Submission on the RCL Homestead Bay Fast Track Application Proposed Subdivision Consent Conditions (QLDC)

To: The Homestead Bay (Lot 8) Fast Track Expert Panel

Odour Concerns from proposed WWTP

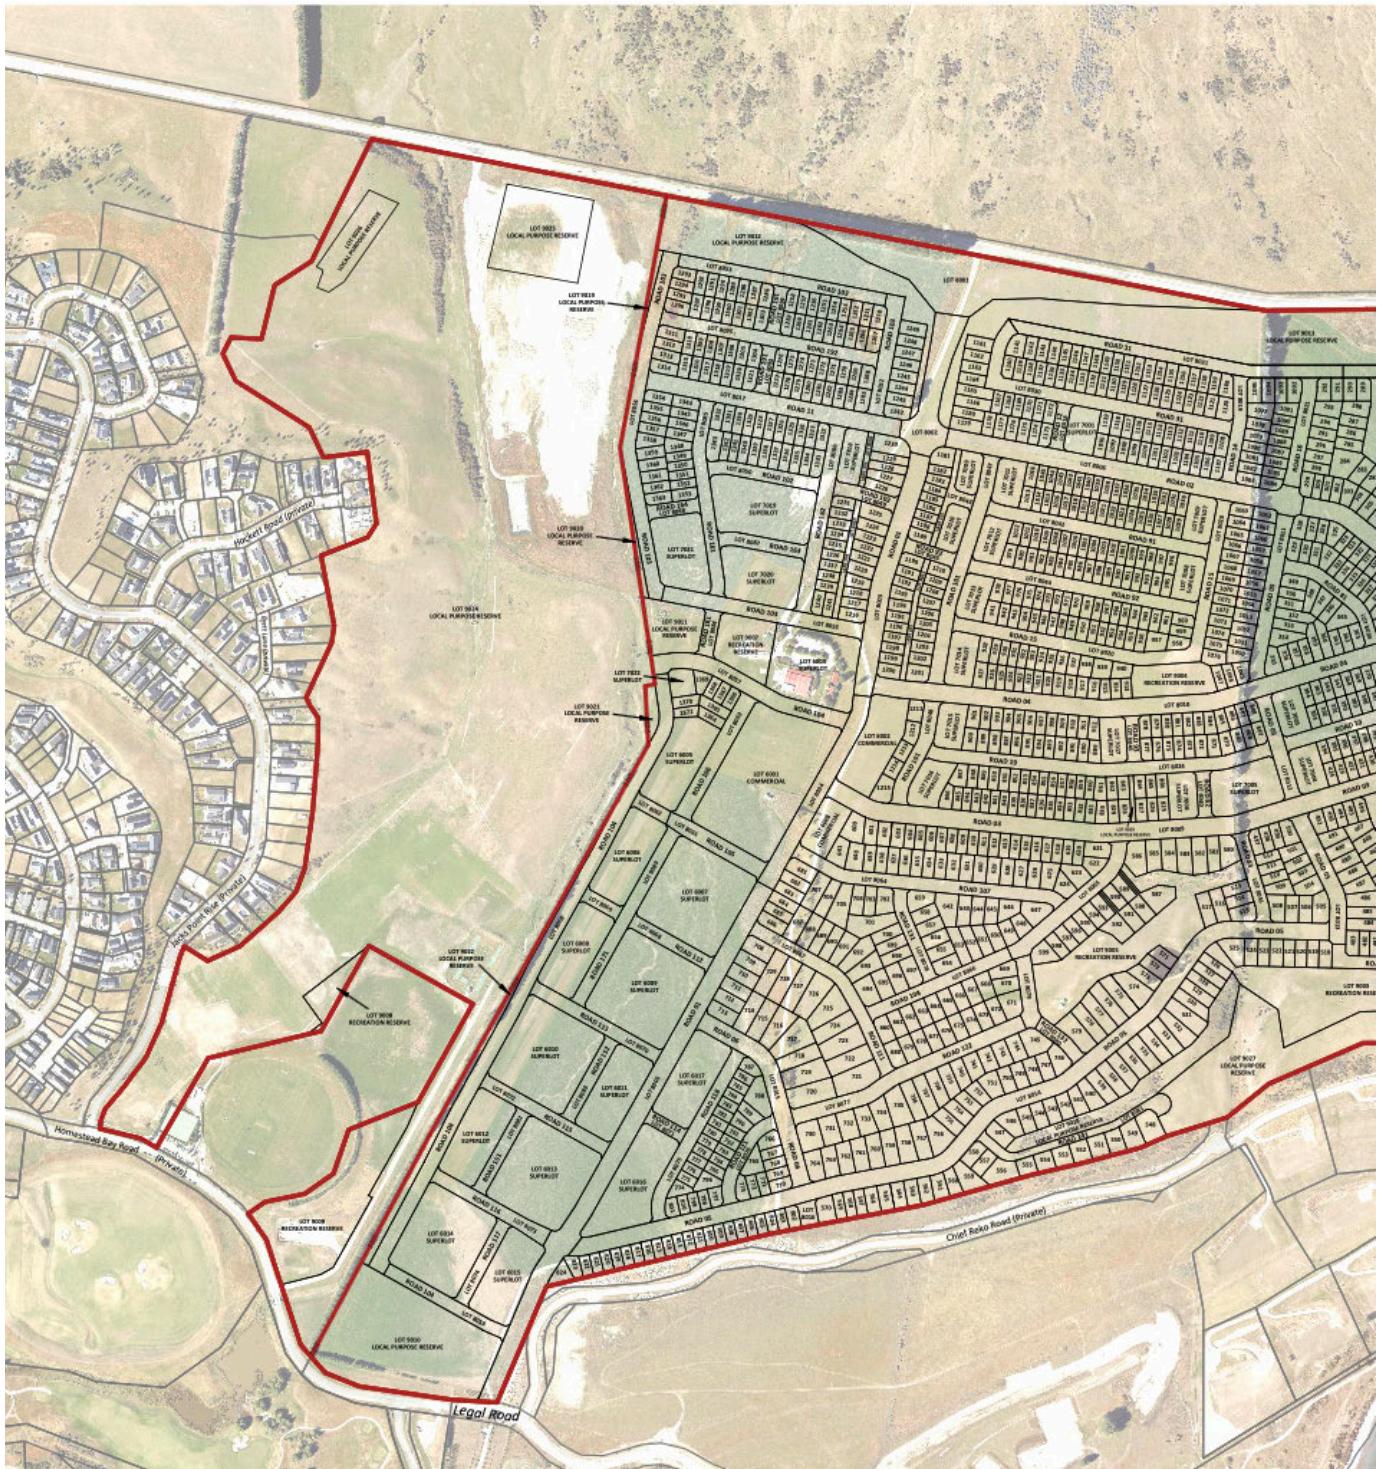
We object to the waste water treatment plant being located even closer to Jacks Point homes and sports fields. Placing a utility of this nature within the direct line of sight of residents is unacceptable. This treatment plant will significantly compromises the area's residential and recreational value. We urge that the facility be located at the southeastern boundary near the highway and Lot 8, ensuring it is both out of sight and at a maximum distance from our community and to ensure it is effectively screened from view and distanced from homes. I also question the practicality of the wastewater running uphill to the fields.

I am quite surprised at this suggestion. Perhaps the Panel's assessment is based on a **fundamental error** regarding the site's orientation. By assuming north is 'up' on the plans? If so the Panel has overlooked the true direction of the prevailing winds, leading to a significant failure in recognizing the gravity of the odor issues facing Jack's Point."

Note: North is on left hand side on the 'Appendix-M-Subdivision-plans' not 'UP' meaning prevailing wind is coming from the proposed subdivision carrying odours and dust to existing Jacks Point residents and community.

Figure 7-1 99.9th Percentile 1-hour average odour concentration for a 6 m OCU stack height

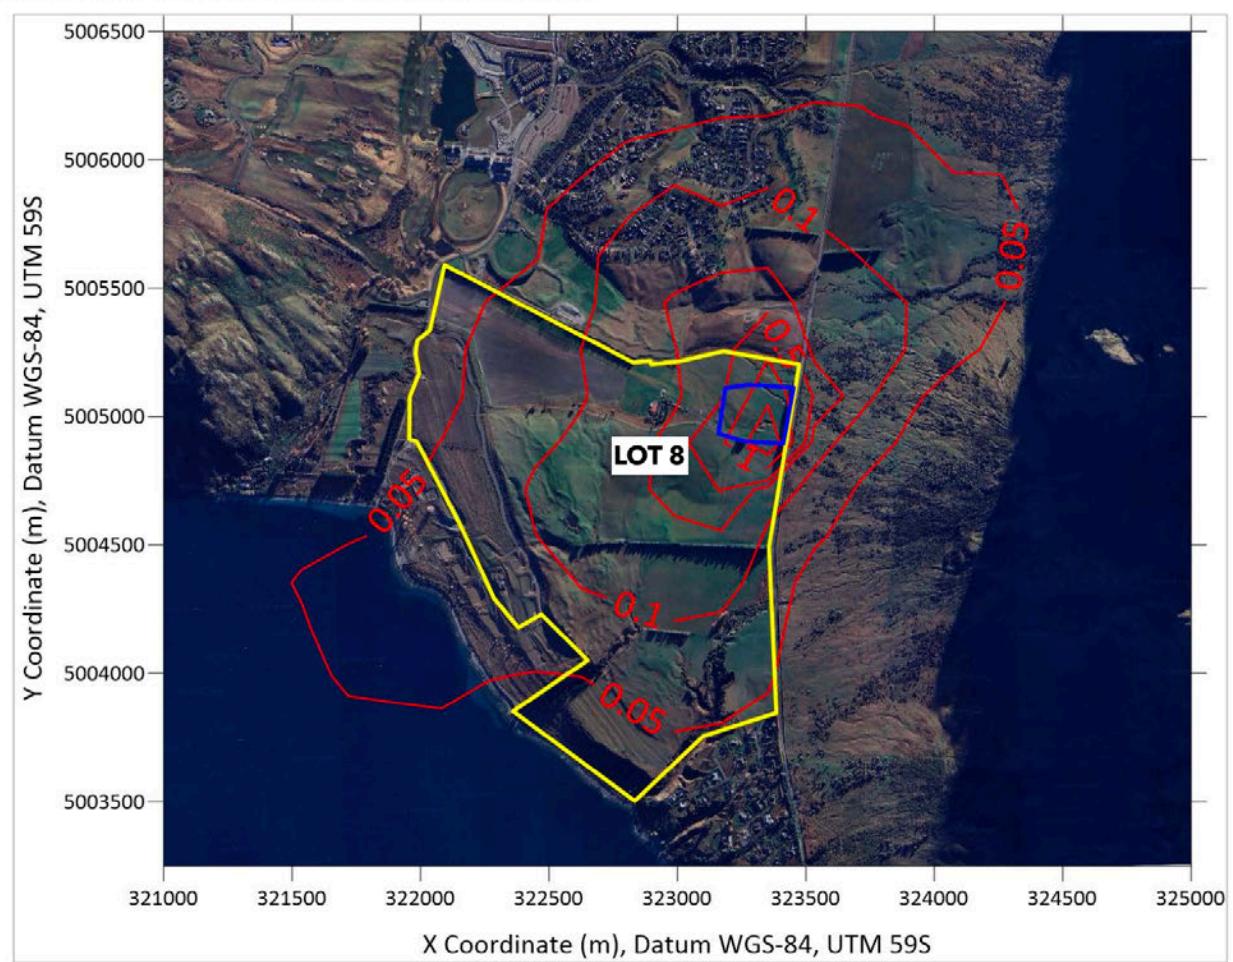
- What specific technologies or redundancies will be implemented at Homestead Bay to ensure a "zero-odour" threshold? The 'Appendix-OO-Odour-Impact-Assessment' clearly show that odours will reach our community, even in the location shown on LOT 8 which is further away from Jacks Point residents.
- How will the developer mitigate the geographical reality that Jacks Point residents—rather than Homestead Bay residents—will bear the brunt of any failures in odour control?
